Joint Meeting of Experts on the Regulations annexed to the European Agreement concerning the International Carriage of Dangerous Goods by Inland Waterways (ADN) (ADN Safety Committee)**Thirty-seventh session**

**Proposals for amendments to the regulations annexed to the ADN:
other proposals**

**Supporting reaction of EBU/ESO to
ECE/TRANS/WP.15/AC.2/2020/36 (NL) and
ECE/TRANS/WP.15/AC.2/2021/03 (D)****Transmitted by EBU and ESO**

A closed system (preference of EBU/ESO):

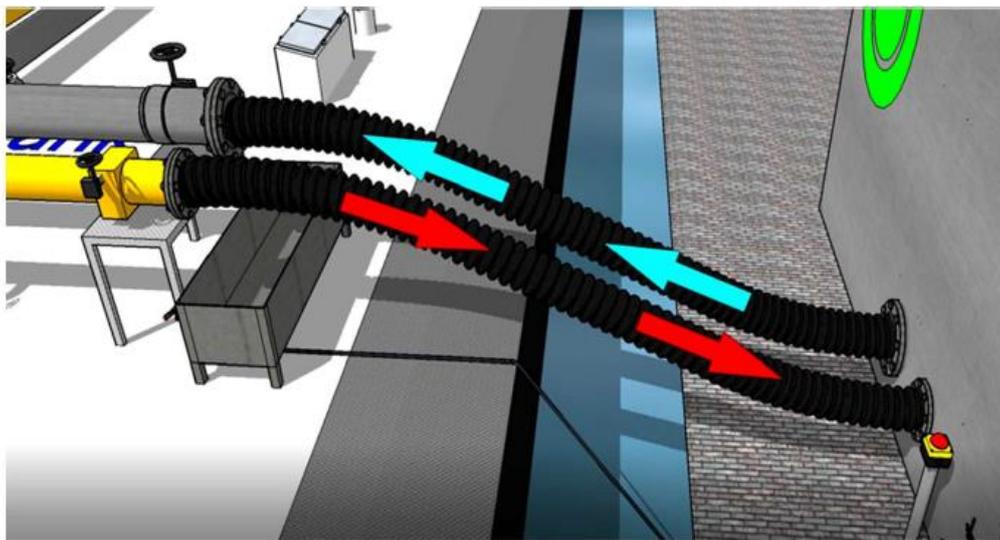
10. 2 pipes/hoses are connected, air from 'shore':

- (a) Connection of portable low-pressure valve on **liquid end flange of barges manifold**:

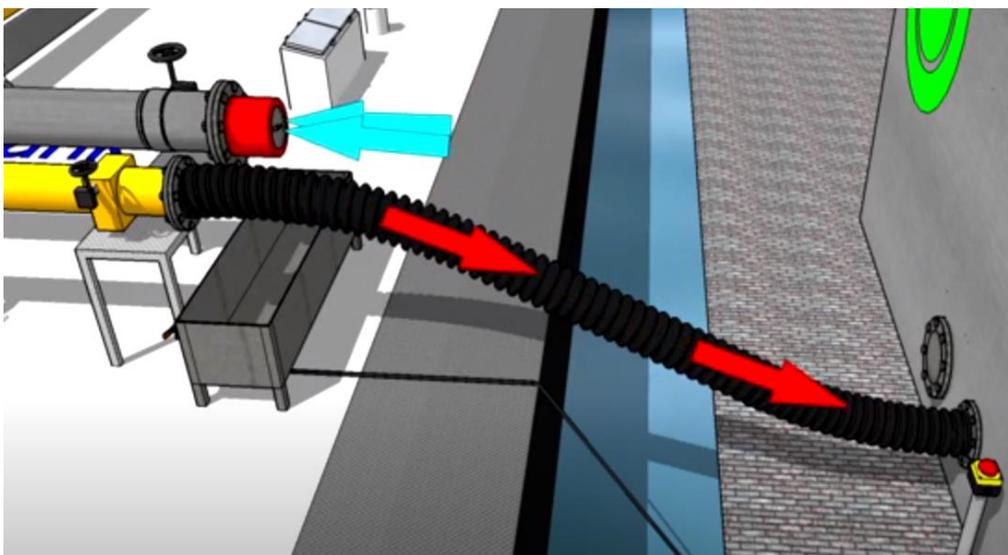
11. Portable (NOT-SPRING LOADED) low pressure vacuum valve.

This should be seen as **possible option, not an obligation** to have such a valve on board. It can also be brought on board from the reception facility, been connected before and disconnected after the degassing has been finished (and returned to the shore).

The portable low pressure vacuum valve could be installed on the manifold of the barge, in this case on the end-blind-flange where during loading and unloading the arm/hose for loading/unloading is connected, but also on the vapour return line or in the middle of the cross-over

(c) Connection to the blind flange in the center of the crossover of a barges manifold.

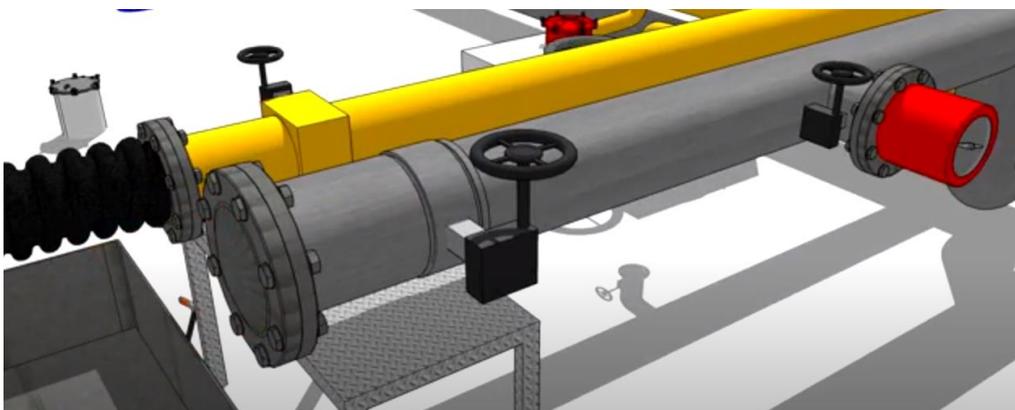
This is mostly also the connection on which the hose is connected from the barges ventilator to degas to the atmosphere, when the barge is underway.
